# INVITATION FOR BID (IFB) No. IFB-PAG-CIP-022-007 PAINTING OF EXTERIOR, INTERIOR, AND ROOF COATING OF THE PAG CFS BUILDING

# ADDENDUM NO. 1 DATE: August 2, 2022

### QUESTIONS AND RESPONSES FOR CFS BUILDING PAINTING BID (IFB-PAG-CIP-022-007)

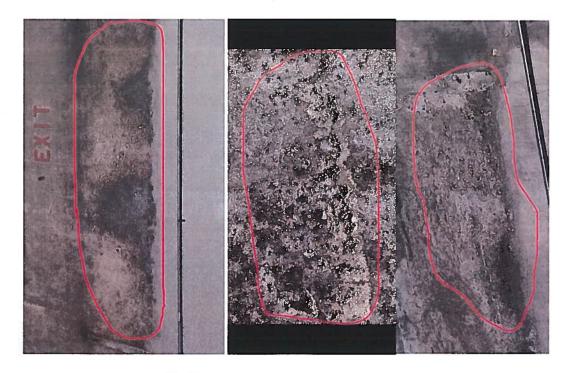
2. It was mentioned during the site visit that there is an existing roof coating and bidders can request photos of the roof. So, can we please request the latest photos of the roof to help us

understand its actual condition? In the bid schedule there is no line item for removal of existing coating, please clarify also.

**Response:** Yes. Refer to Addendum No.1 attachment(s). Do not remove existing roof coating, unless they are required in some isolated areas only.

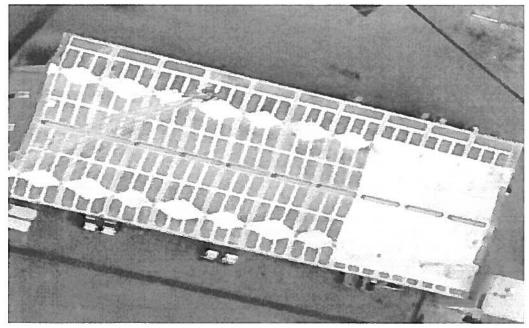
4. Per the photos below, some rough surfaces can be found both on the interior and exterior of the building. Please advise if we will include patching and grinding in our proposal and in what line item it will be inserted.

Response: Refer to Amendment No. 2 – Revised Bid Schedule Line item 7. Please provide plastering unit cost per square foot.
